INDEX OF STRUCTURAL DRAWINGS

**KUHIO HIGHWAY SHORT-TERM
IMPROVEMENTS KUAMOO ROAD
TO TEMPORARY KAPAA BYPASS ROAD**
Fed. Aid Proj. No. NH-056-1(50)

"AS-BUILT"

SECTION A
Scale: 3/8" = 1'-0" S2.2 | S2.2A

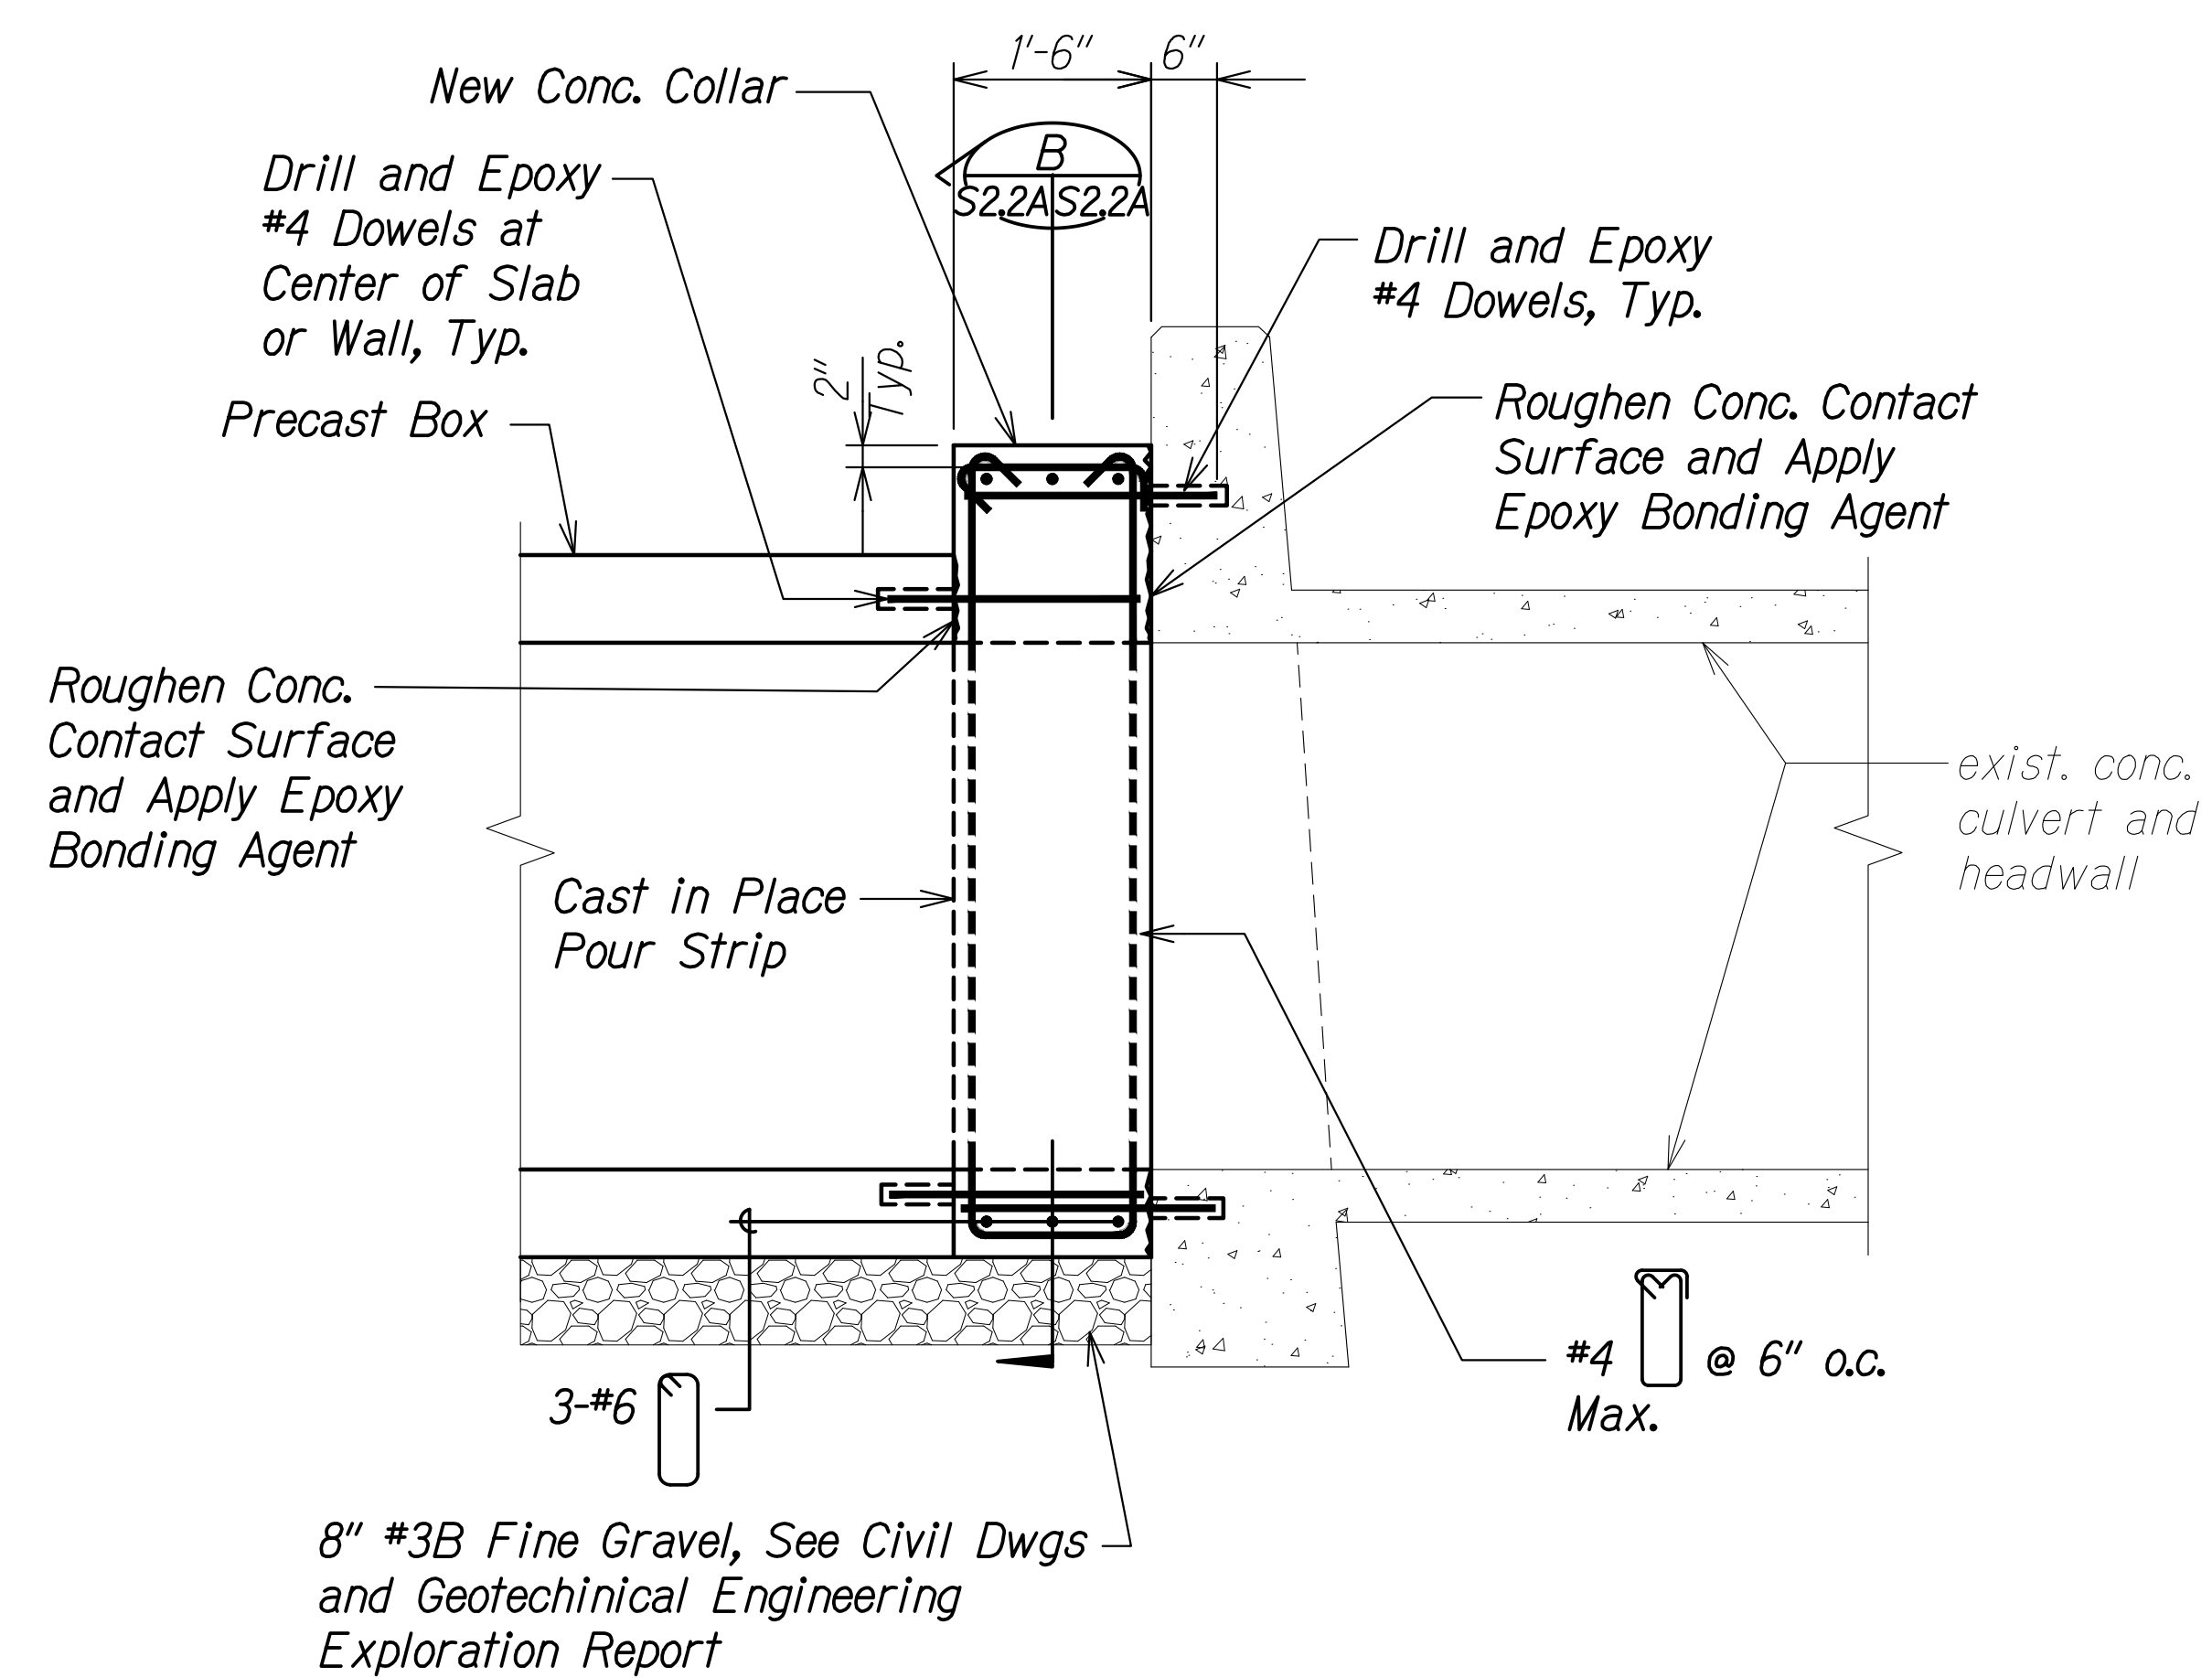
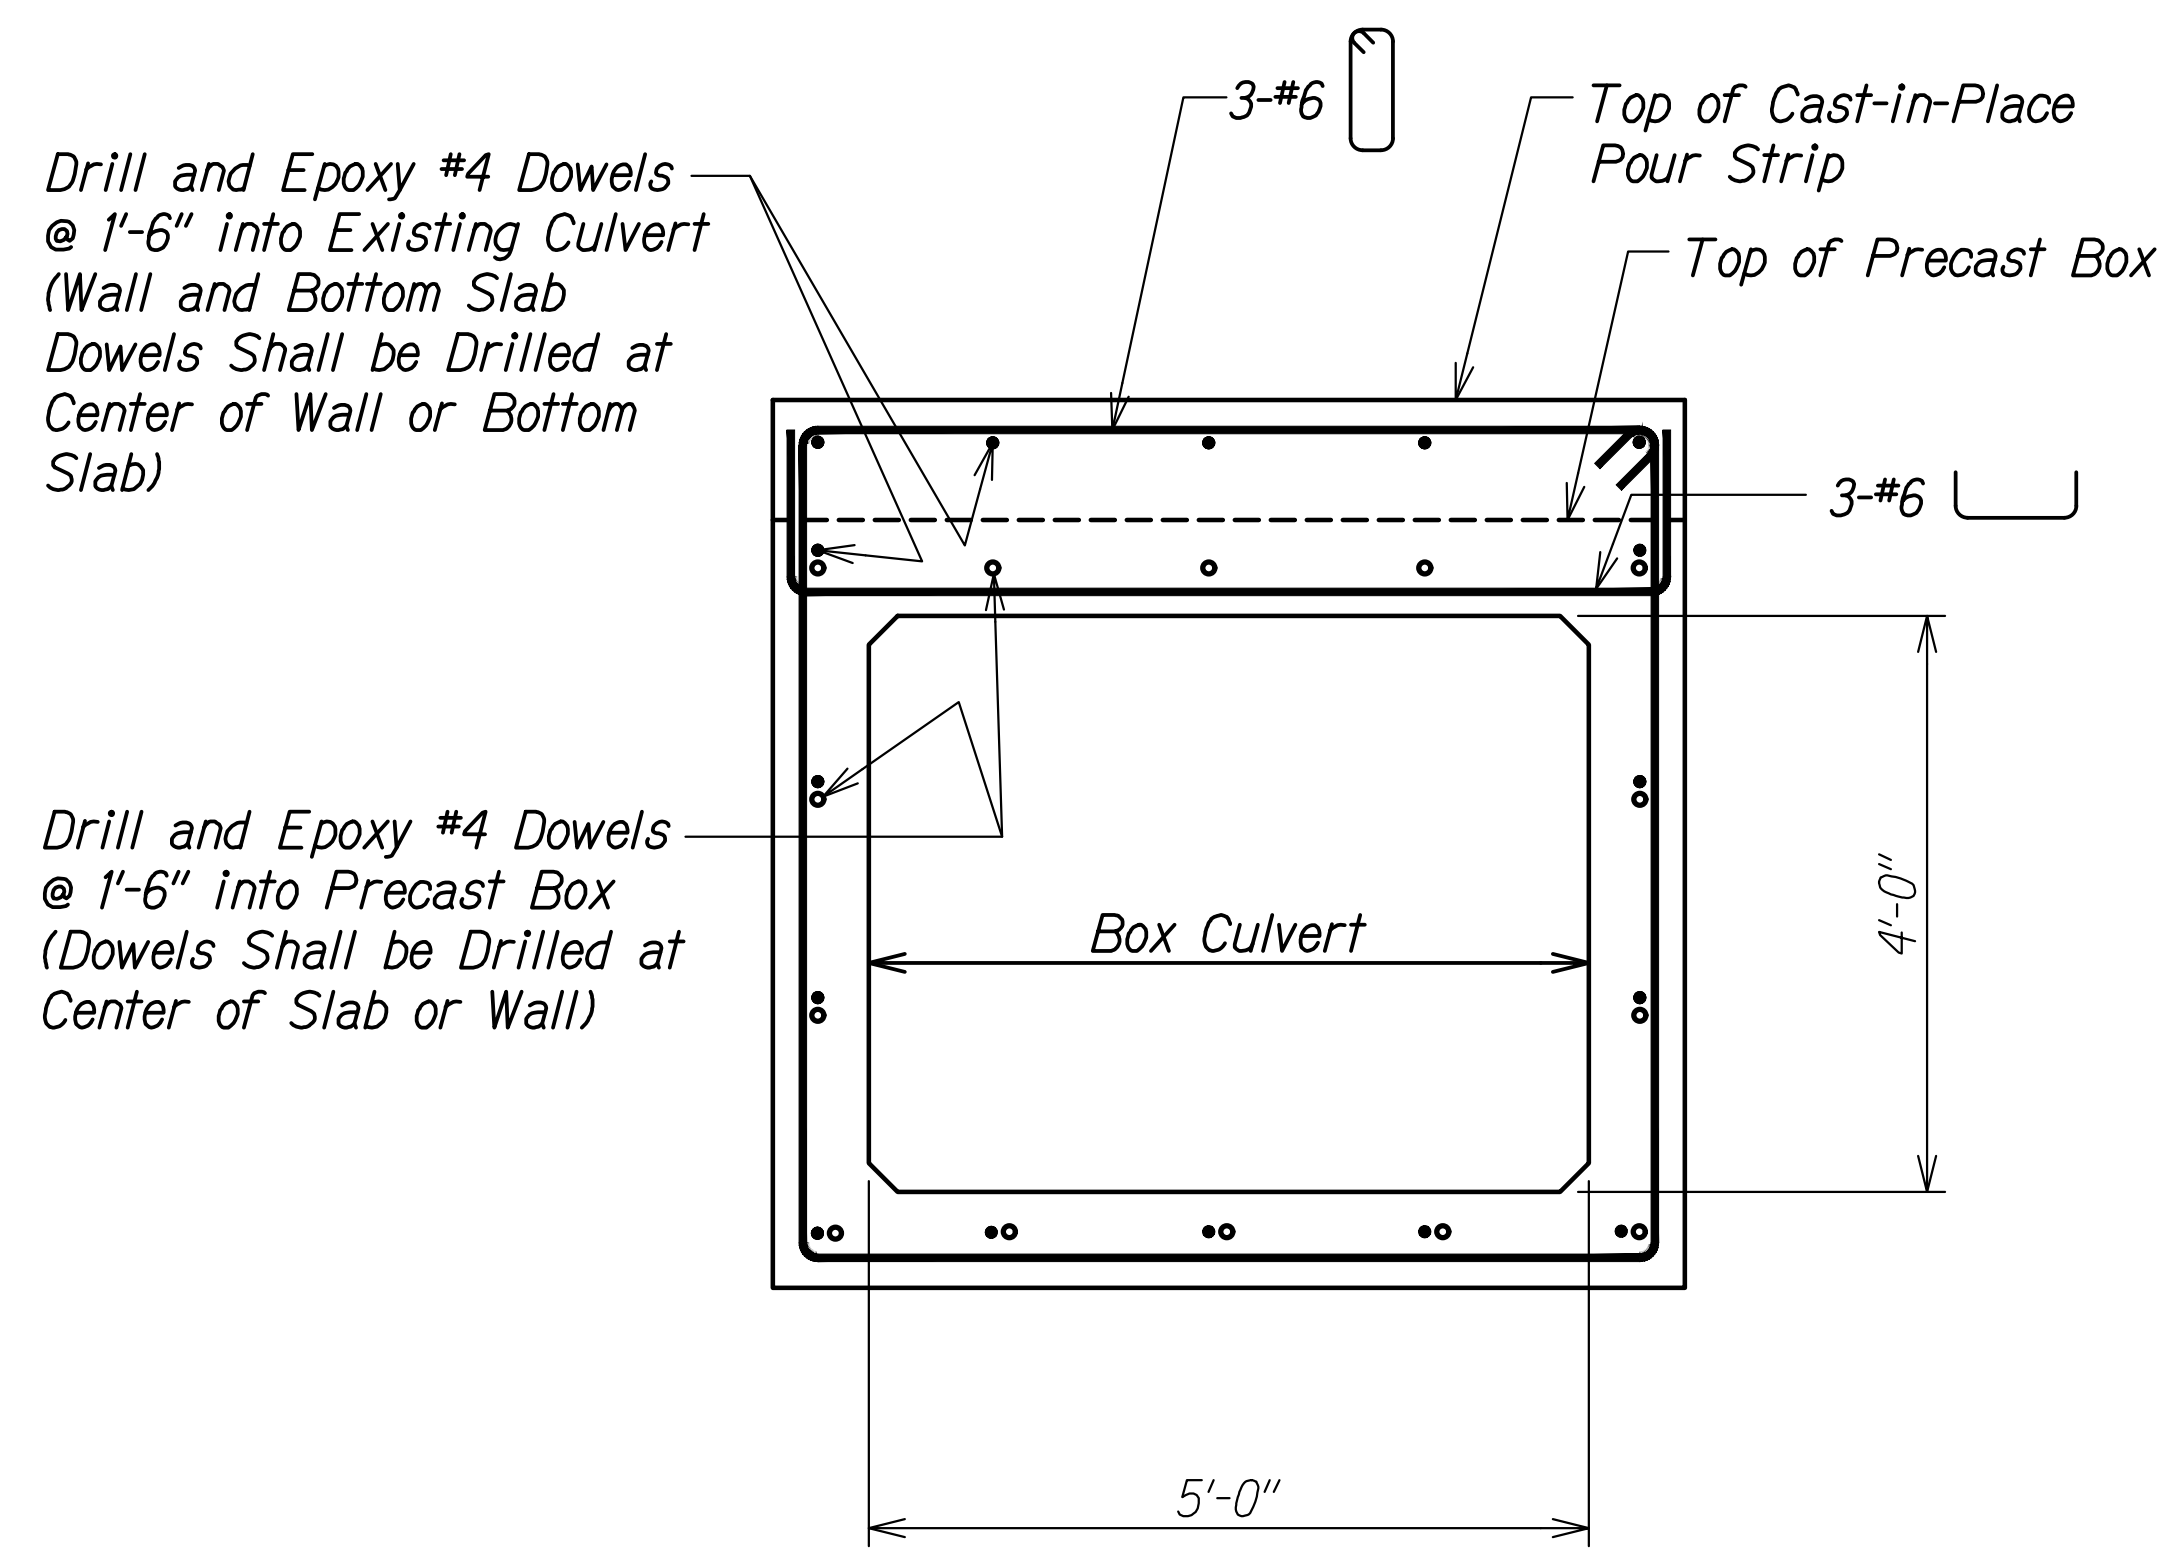
| 5/4/22 | New Sheet RFI 121 Refr. S2.2 |
